TMI-09-107
November 9, 2009

Three Mile Island Nuclear Station, Unit 1
Renewed Facility Operating License No. DPR-50
NRC Docket No. 50-289

Subject: Response to Request for Additional Information Regarding Generic Letter
2004-02

Figure 2: Floor area where large pieces of Nukon® would transport to the sump

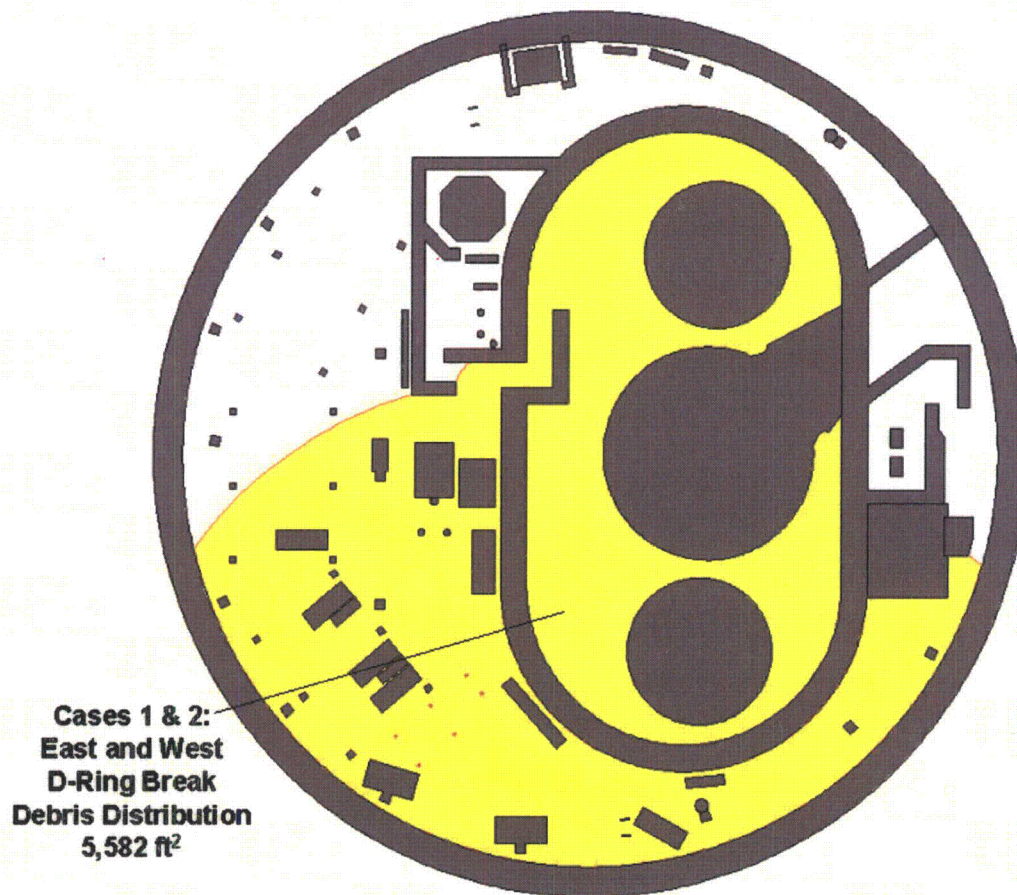
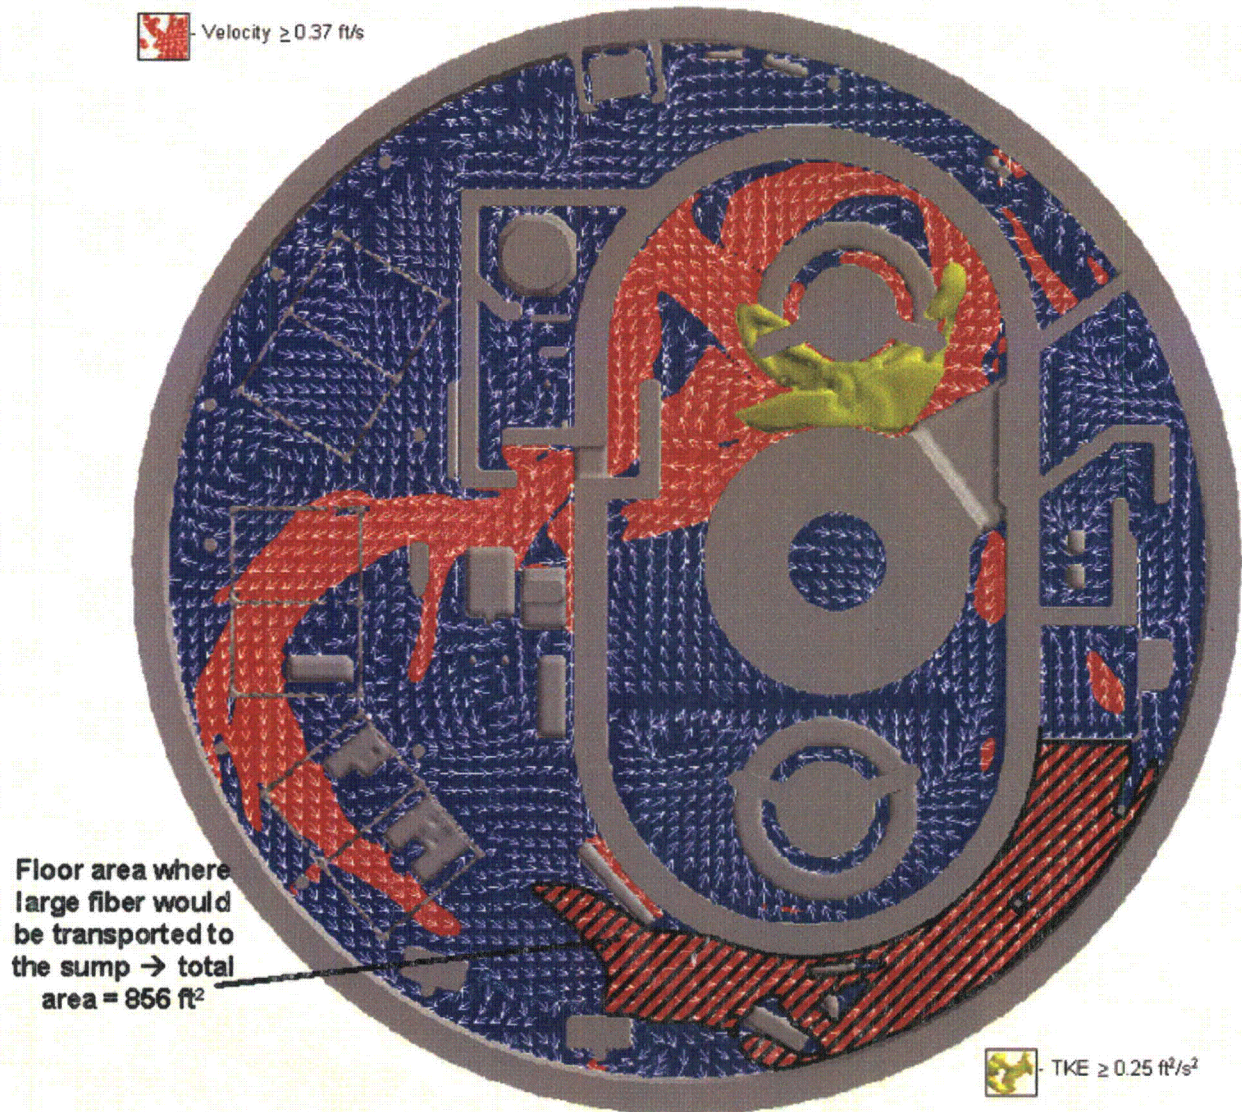
The staff requested that the licensee provide the post-transport size distributions for the reflective metal insulation, and jacketed and unjacketed Nukon® insulation debris with justifications for the transport fractions (e.g., erosion effects). The GSI-191 Safety Evaluation Report, "Pressurized Water Reactor Sump Performance Evaluation Methodology," states that erosion may be neglected if the licensee follows the baseline methodology and considers transport fractions for large debris pieces. The staff noted one apparent inconsistency in the information that was provided regarding the transport of large pieces of fiberglass. Specifically, the information provided in Table 2 of the RAI response indicates that a transport percentage of

15% for large pieces was assumed; however, a note to Table 2 indicates that large pieces are not transported to the sump, and that erosion is also not considered. Further, the licensee has not provided adequate justification (e.g., computational fluid dynamics and experimental debris transport metrics, test results, etc.) for the 15% assumption. The staff requests that the licensee clarify the transport fraction assumed for large pieces of fiberglass debris, state whether it transports as intact large pieces or eroded fines, and provide the technical basis used to derive this transport fraction. Please also clarify whether the transported large debris was modeled in the head loss testing conducted for TMI-1 and identify its prepared size distribution.

A transport fraction of 15% for large pieces was determined in the TMI, Unit 1 Debris Generation Calculation. The CFD model showed that turbulence in the pool is not high enough to suspend large pieces of Nukon® throughout most of the pool. Since the large pieces of Nukon® would settle in most of the pool, the tumbling velocity is the predominant means of transport. The large pieces of Nukon® were assumed initially to be uniformly distributed between the locations where it would be destroyed and the sump (Figure 1, below). This area was overlaid on top of the plot showing the tumbling velocity and flow vectors to determine the recirculation transport fraction. The area where large pieces of Nukon would transport is approximately 15% (856/5582 ft³) of the total initial distribution area (Figure 2, below).

The 15% of large pieces assumed to be transported was included in the total quantity of Nukon® transported to the sump as identified in Table 2 (Reference 3). This total quantity of Nukon® (199 ft³) was used to determine the quantity of debris to be used in the head loss testing based on the appropriate scaling factors. All Nukon® debris used in the head loss test was prepared in the same manner, regardless of whether it was assumed to be transported as small or large pieces. The debris preparation procedure was described in the previous response to RAI 7 (Reference 3) and additional information is provided in the response to USNRC Question 3, below.

Figure 3: LPI NPSH - Maximum Reactor Building Cooldown – Case I

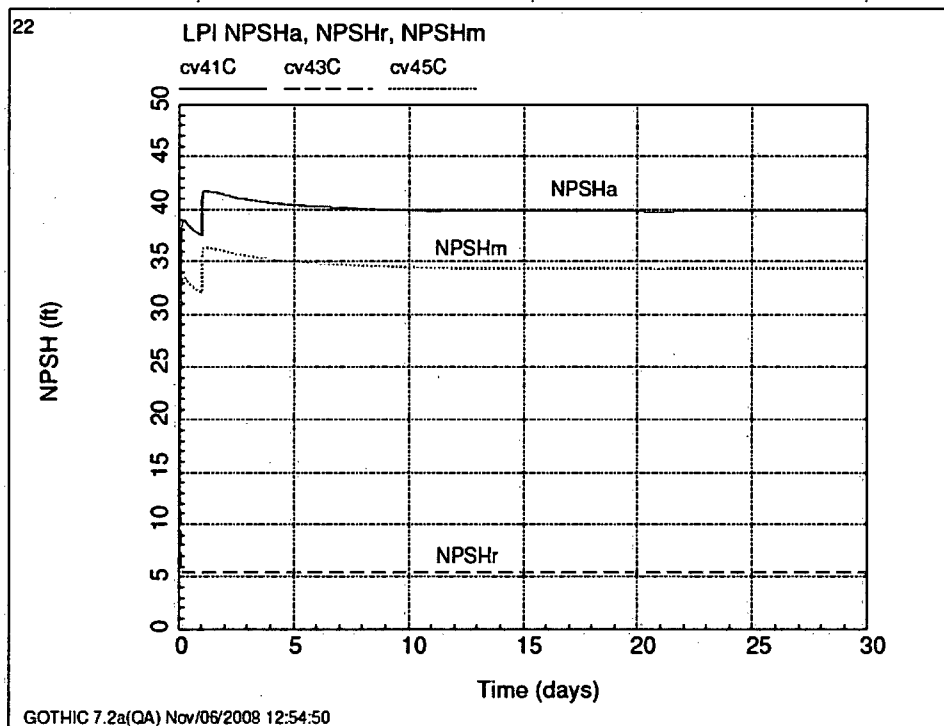
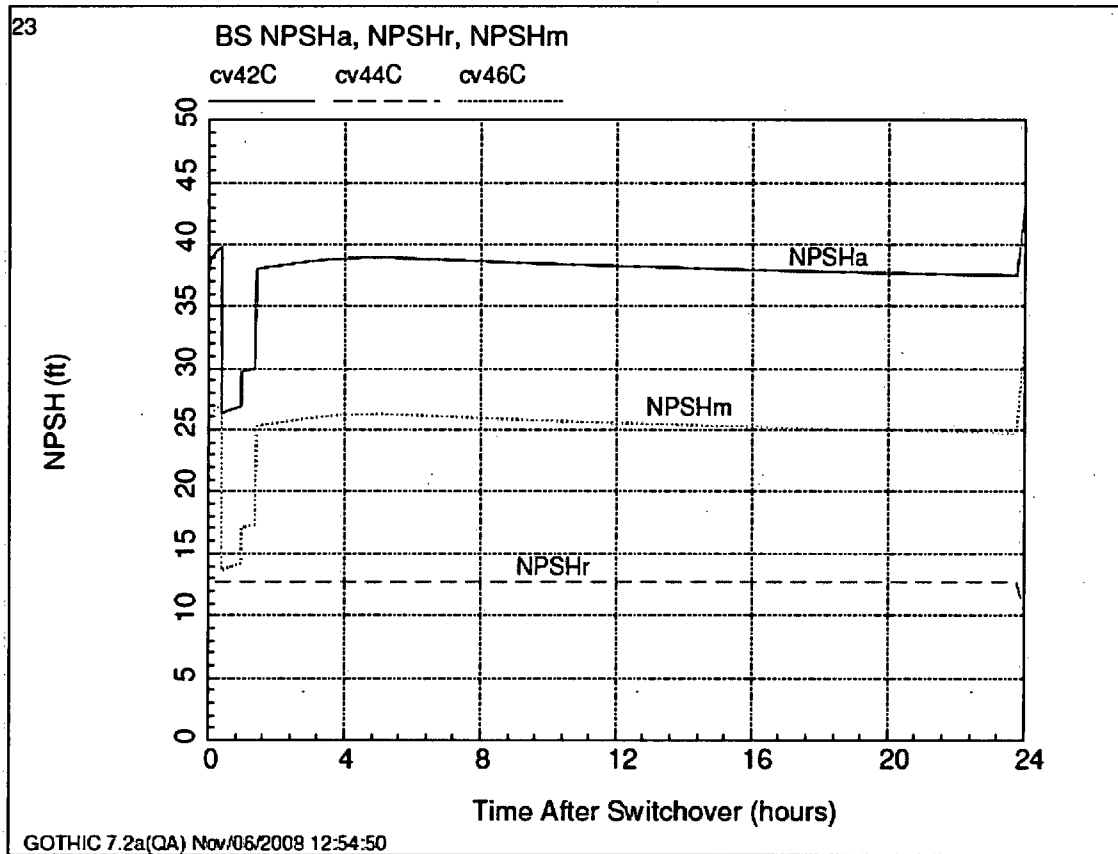
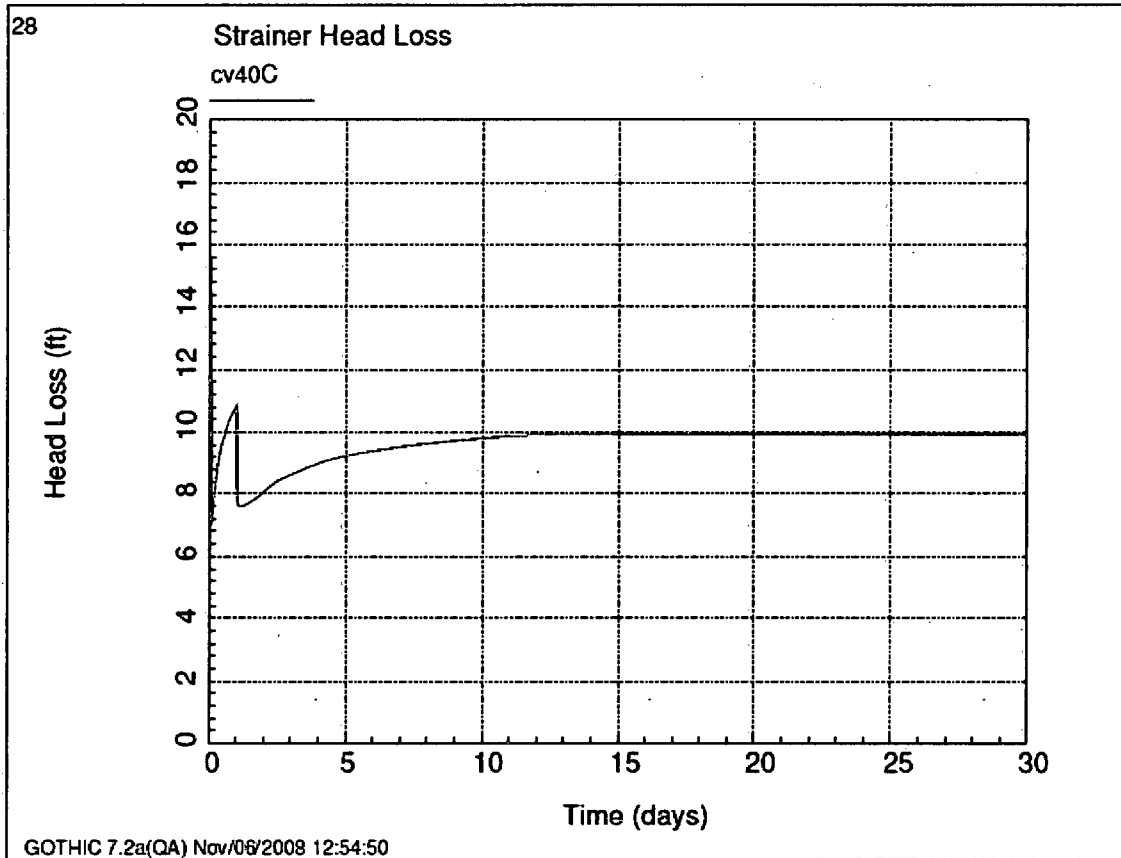
The staff requested additional information on how the extrapolation of head loss results to the strainer mission time would affect the head loss evaluation. The licensee provided additional information that clarified some aspects of the need to perform an extrapolation of the data to the pump mission time. The licensee response to the RAI is reasonable. In addition, the rate of increase of head loss over the last 12 hours was very small such that less than one foot additional head loss would likely occur over the strainer mission time. However, the TMI-1 supplemental response states that the limiting NPSH margin for the low pressure injection (LPI) pump single operation is 0.1 ft. This is a relatively small margin. The variance of margin related to time was not provided. Because of the low margin available, the licensee should verify that the evaluation of the head loss test data did not include a non-conservative assumption regarding extrapolation that could affect the available pump margin throughout the mission time.

The maximum stable strainer head loss measured after the addition of the calcium phosphate precipitates in the TMI Unit 1 head loss test was 1.7 ft. As discussed in the previous response to Issue 3f.10 (Reference 1), the test head loss is adjusted for flow rate and temperature when applied in the NPSH analysis. The adjusted head loss due to the total amount of calcium precipitates is applied from the beginning of recirculation to the time when sump temperatures reach 140°F. This includes the time of minimum NPSH margin, which occurs in the first few hours following initiation of sump recirculation. No non-conservative assumptions that could affect the available pump NPSH margin were identified in the application of the head loss test data to the time in which sump temperatures are above 140°F.

The adjusted head loss based on the maximum observed value of 21.3 ft is applied in the NPSH Margin Analysis when sump temperatures reach 140°F. The increase in head loss at 140°F is applied as a step change and is not phased in over time. Following the step change in strainer head loss, the minimum NPSH margin for the LPI pumps is 11.9 ft (See Tables in Attachment 5). The minimum NPSH margin for the BS pumps is 13.6 ft (See Tables in Attachment 5). The minimum margins for both pumps occur in the maximum cooldown Case I and are coincident with the step change at 140°F. NPSH margin for both pumps increases later in the event as shown in the figures below. With the significant NPSH margins that are available at the lower temperatures, no non-conservative assumptions that could affect the available pump NPSH margin were identified in the application of the head loss test data to the time in which sump temperatures are below 140°F.

The maximum strainer head loss is also evaluated to ensure that the maximum strainer design differential pressure is not exceeded. The maximum strainer head loss always occurs after the sump temperature reaches 140°F, but is dependent upon the timing of termination of BS flow and throttling of LPI flow. As discussed in the previous RAI response to Issue 3f.10 (Reference 1), credit is taken for operator action to secure the BS pumps and reduce LPI flow to ensure the structural limit of 16.15 ft (7 psi) is met for all cases. The maximum strainer head loss of 15.6 ft occurs for the maximum cooldown Case I (See Tables in Attachment 5). Strainer head loss decreases and remains below this value due to the action of securing the first BS pump and subsequent operator actions to throttle LPI flow as shown in the plot below. The operator actions credited for maintaining strainer differential pressure below the design value were shown to be effective. No non-conservative assumptions that could affect the maximum strainer differential pressure were identified in the application of the head loss test data to the time in which sump temperatures are below 140°F.

Figure 6: TMI, Unit 1 Containment Sump Configuration

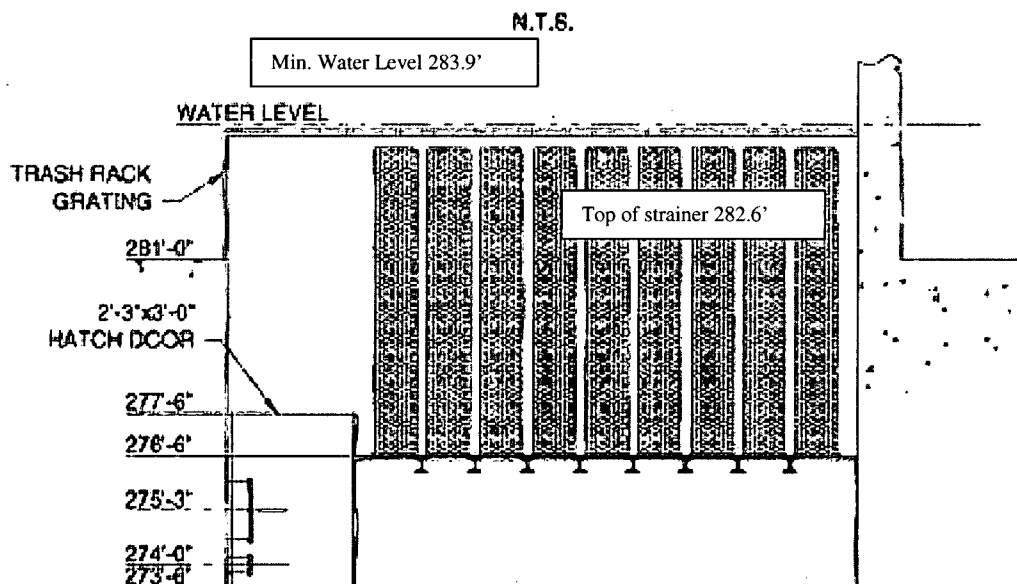
The staff requested additional information on whether containment overpressure was credited for the strainer flashing evaluation. The licensee provided additional information in this area, but it seemed that the question was not understood. The licensee evaluated flashing at the pump suction, but did not address potential flashing in the debris bed or within the strainer. Flashing within the strainer or debris bed can result in additional head losses. The licensee should verify that the potential for flashing at the strainer has been evaluated or provide the parameters such that the staff can verify that flashing will not occur. The minimum margin to flashing at the strainer should be provided. For example, provide strainer submergence, sump temperature, and strainer head loss as a function of time. If required, provide the minimum available containment pressure at the evaluated times.

Based on the review of the vertically oriented screen design in the sump pit, the greatest potential for flashing occurs at the top of the strainer due to the minimum submergence. An illustration of the TMI, Unit 1 strainer is provided in Figure 6. The minimum water level is at elevation 283.9' and the top of the strainer top hat is at elevation 282.6' which provides 1.3' of submergence to the top of the strainer top hat.

As described in the previous response to Issue 3o.2.9.i (Reference 1), the head loss across the strainer at temperatures above 140°F is based on the contribution of calcium phosphate precipitates. As described in the Response to Issue 3f.13 (Reference 1), the measured debris head loss is adjusted based on the temperature of the fluid. Due to the effect of fluid density and viscosity, the debris head loss increases as temperature decreases. The submergence of the strainer is greater than the debris head loss until the sump temperature decreases to approximately 141°F. For the temperatures around 141°F, the fluid pressure determined per criteria 2, above, is above the vapor pressure (see example below for temperatures at or below 140°F). Therefore, flashing does not occur for temperatures above 140°F.

As described in the response to Issue 3o.2.9.i (Reference 1), the head loss across the strainer at temperatures below 140°F includes the contribution of aluminum based precipitates. This results in a significant increase in strainer head loss as discussed in the response to USNRC Question 4 (RAI 9). As described in the Response to Issue 3f.10 (Reference 1), operator actions to secure the BS pumps and reduce LPI flow will maintain the strainer DP below the strainer design limit. The flashing evaluation conservatively uses the strainer design DP (16 ft) as the maximum debris head loss. The debris head loss is greater than the submergence of the strainer below 140°F, therefore criteria 2 is applied. The fluid pressure at the top of the strainer is slightly greater than 7 psia [13.7 psia + 0.5 psia (or 1.3 ft.) – 6.9 psia (or 16 ft.)], which is well above the vapor pressure of 2.9 psia. Therefore, flashing does not occur for temperatures below 140°F.
